Electrical Safety Assessment Report

TSS-FASHION

Telerchala, Mouchak, Kaliakor, Gazipur, Bangladesh.
24.0228444 N, 90.3003772 E

Date of Assessment : 14 Oct 2021
Report Code : 145_CP_2021_1170_TSS-FASHION_ESA_V00
Report Version : V00_14 October 2021
Name of the Assessor : Imtiaz Mahmud
Assessing Firm :

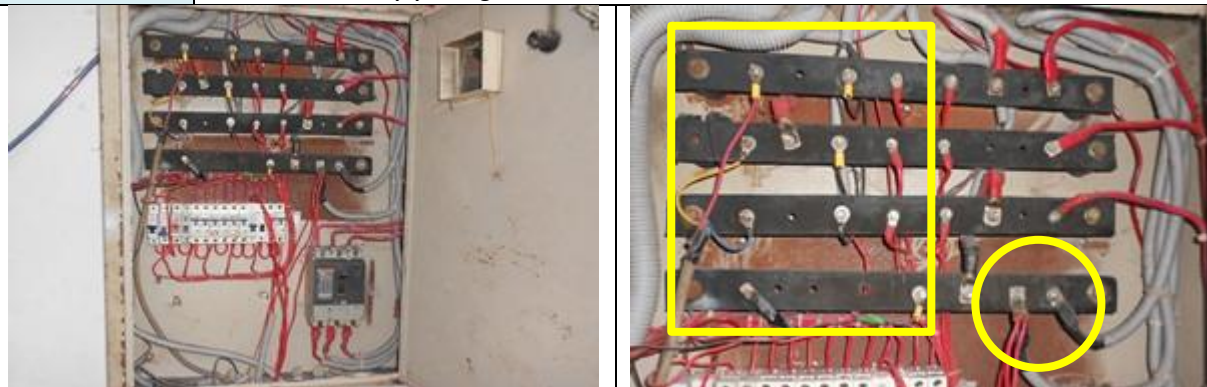
43	Is there insulated support provided for high overhead service entries?	Risk Level	Low
		Time line	6 Weeks
Section	Electrical distribution system		
Observation	Proper support was not provided for high overhead service entries.		
Location	From pole to Generator room		
Corrective Action	1. Overhead service connections should be covered and meet the requirements mentioned in BNBC. 2. Provide supports for main service line complete with adequate insulation.		
References	BNBC-1.3.26; Page- 4590

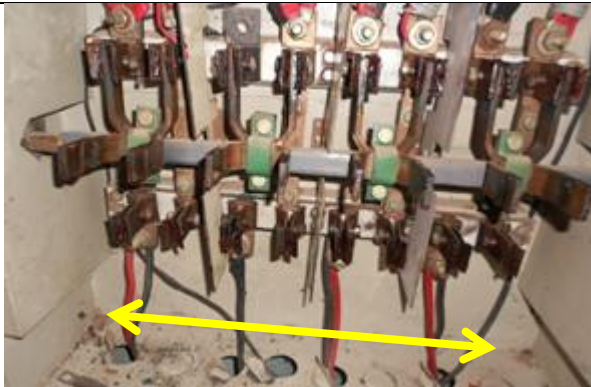
47	Is there over current protection device installed at all distribution panels?	Risk Level	Very High
		Time line	6 Weeks
Section	Electrical panels		
Observation	Over current protection device was not installed.		
Location	MDB/1st Floor		
Corrective Action	Over current protection devices (Circuit breakers) should be installed at all distribution panels.		
References	BNBC-1.3.30 (a); Page-4595

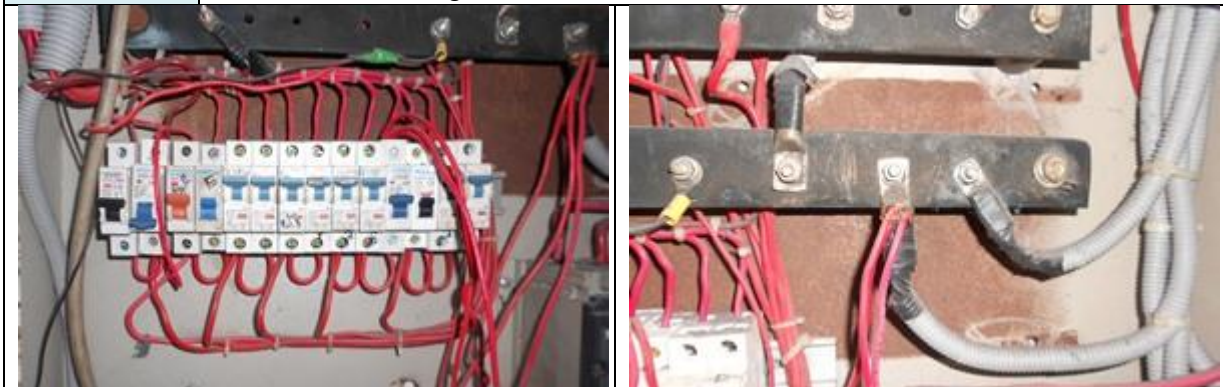
50	Are electrical connections properly secured with lugs and glands?	Risk Level	High
		Time line	6 Weeks
Section	Electrical wirings		
Observation	Cable connections provided without proper lugs and glands.		
Location	All Distribution boards		
Corrective Action	Provide cable connections with properly soldered / welded lugs at (LT/MDB/DB/SDB)'s. Ensure that all the electrical connections are properly secured with lugs and glands.		
References	BNBC-1.3.9.2 (d); Page-4569

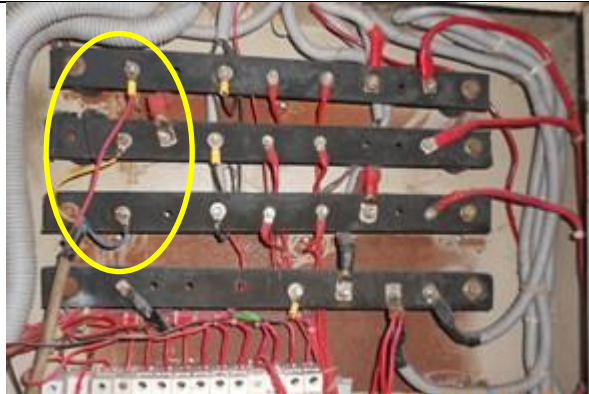
55	Is wiring diagram/ circuit list with proper current ratings are available on every distribution boards?	Risk Level	Low
		Time line	6 Weeks
Section	Electrical wirings		
Observation	Wiring diagram / circuit list with proper current ratings were not available.		
Location	All Distribution boards		
Corrective Action	Provide circuit diagram /circuit list with proper current ratings and fuse size, marking for DBs identifying end use, voltage, no. of phases.		
References	BNBC-1.3.29 (d); Page-4594

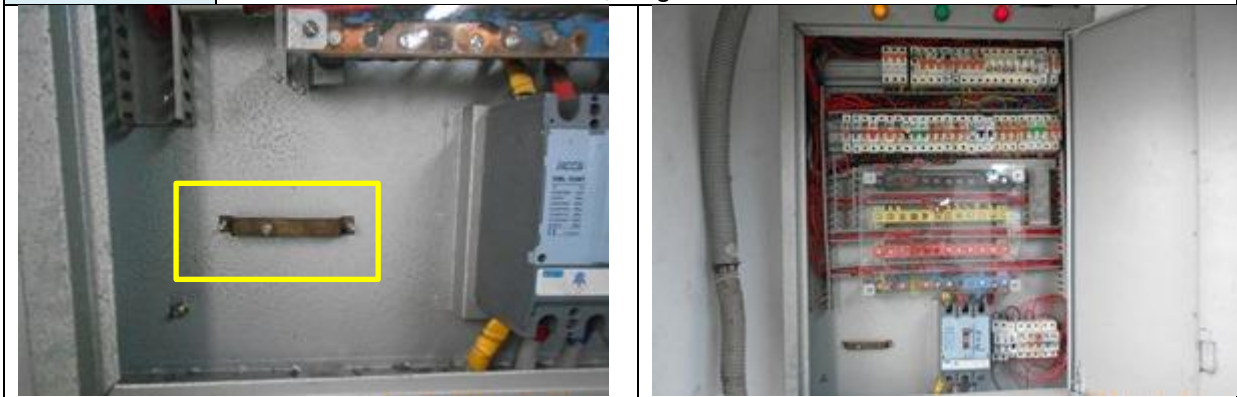
62	Is cable entry-exit point to the panel properly sealed?	Risk Level	Very High
		Time line	6 Weeks
Section	Electrical wirings		
Observation	Cable entry exit points were not sealed properly.		
Location	All Distribution boards		
Corrective Action	Seal the cable entry-exit points of (LT/MDB/DB/SDB) with non-flammable materials. In addition: 1. Ensure that HT / LT panels / Switchgears to be vermin / damp proof. 2. Ensure all unused holes / openings in DBs to be blocked properly.		
References	BNBC-1.3.42; Page-4618

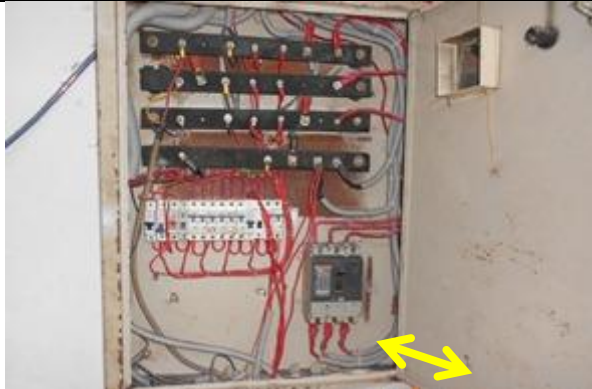
65	Is there proper grounding / earthing of generator provided?	Risk Level	High
		Time line	6 Weeks
Section	Earthing System		
Observation	There was no grounding / earthing of generator provided		
Location	Generator room		
Corrective Action	Provide proper separate earthing/grounding to generator. Ensure that generator body frame to have two separate and distinct connections to the earth / ground.		
References	BNBC-1.3.42.3 (v), Electricity Rule-2020; clause-46; Page 11243-11245
